Burst Terminator Implementation, Rev.2

Frank Effenberger
Huawei Technologies

Insert a new Fig. 92-15a

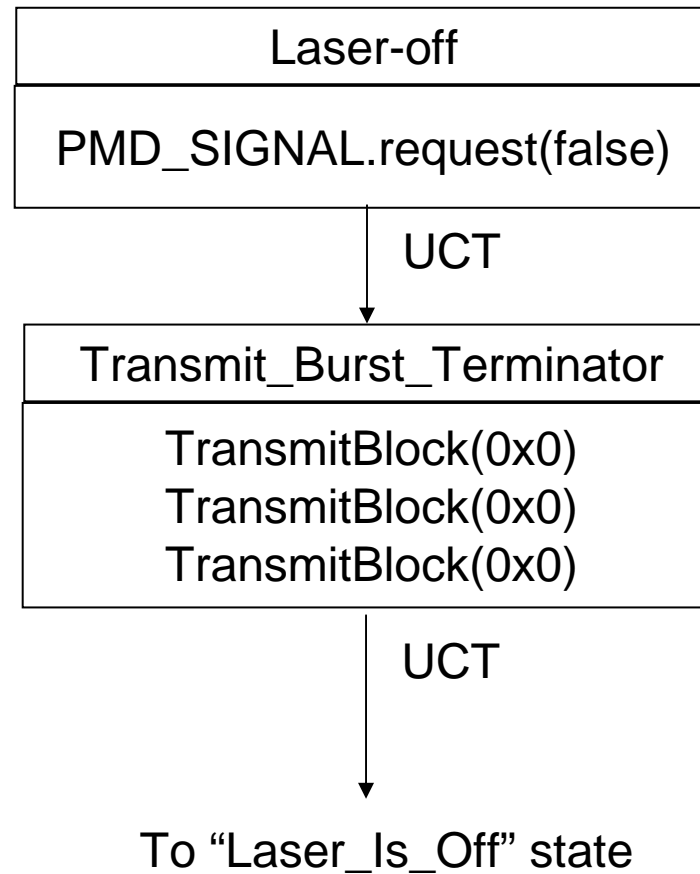
Add paragraph at p.72, I.49

The ONU burst transmission ends with a burst terminator pattern of 3 blocks of all zeroes (see Figure 92–15a). When received at the OLT, the burst terminator allows for the rapid reset of the OLT FEC synchronizer, so that it can search for the next burst. The burst terminator is not part of the last FEC codeword. Note that while the burst terminator is part of the ONU burst transmission, the laser-off commences at the beginning of the burst terminator. This is possible because transmitting all zeroes and turning the laser off are equivalent to the same thing: emit no light.
